Radiance Fashion Ltd (Extension)

24 November 2025

1. RFL (Extension) Building 1: Four-storied reinforced concrete (RC) building with underground water reservoir.

Observation 03: Lack of floor load management.

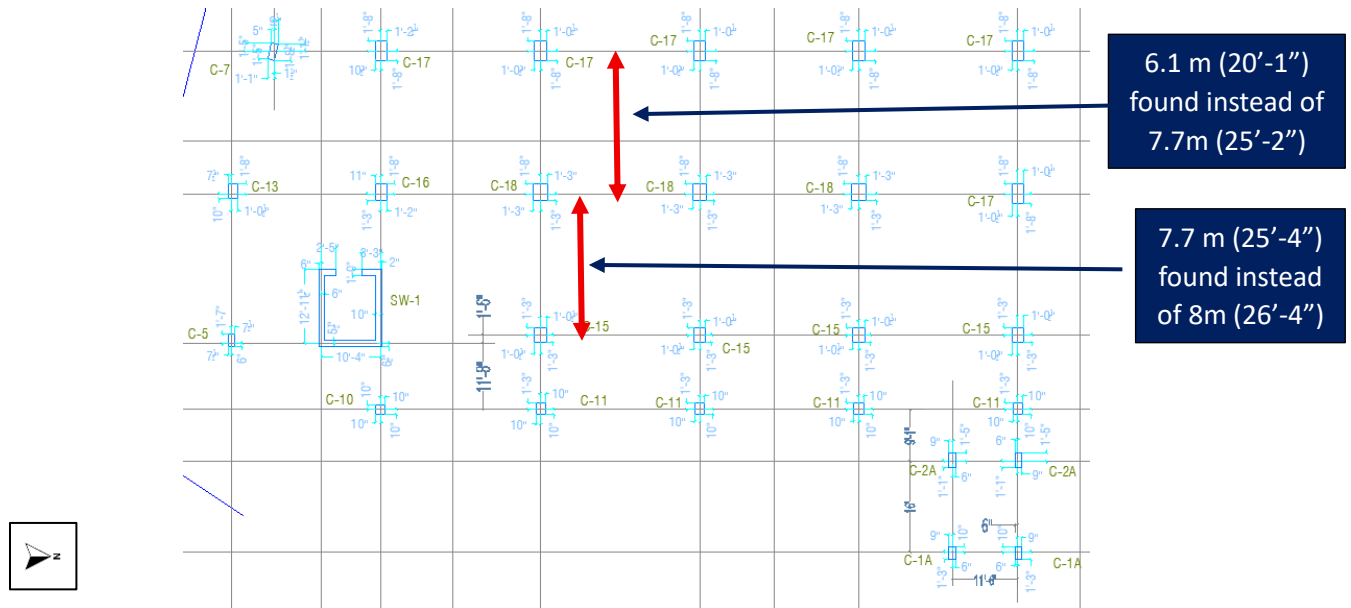
Description: During the inspection, the building was found to be used for storage; however, no load plan or storage height markings were provided. The building engineer is required to produce load plans as per BNBC, post the load plans at each floor, provide storage height marking and maintain floor loading accordingly.

7.	Lack of floor load management.	Implement floor load management program (post load plan, mark storage height and maintain floor loading accordingly.	within 6 weeks

Mismatches in grid dimension

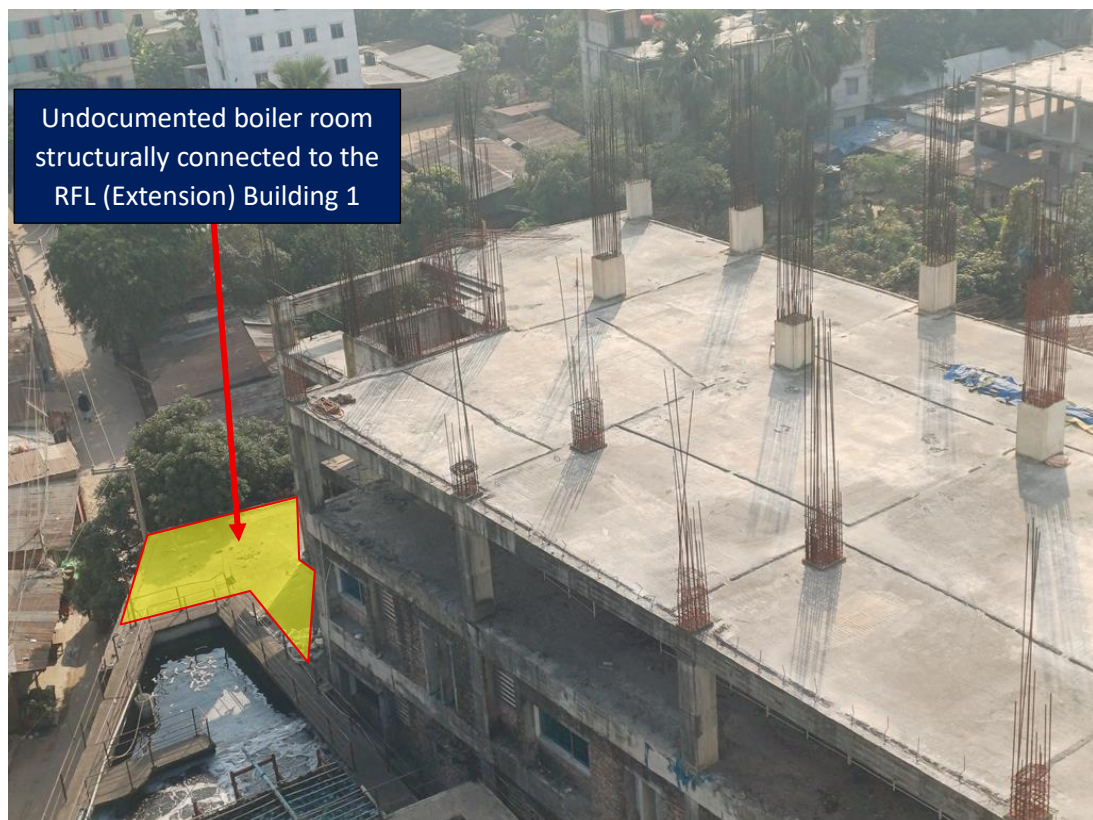
Description: Several discrepancies were identified, including mismatched grid dimensions and an undocumented extension (boiler room). The building Engineer is required to survey the entire structure and produce the as-built drawings to reflect the on-site conditions.

8.	Discrepancies in construction drawing.	The building Engineer is required to survey the entire structure and produce the as-built drawings to reflect the on-site conditions.	within 6 weeks
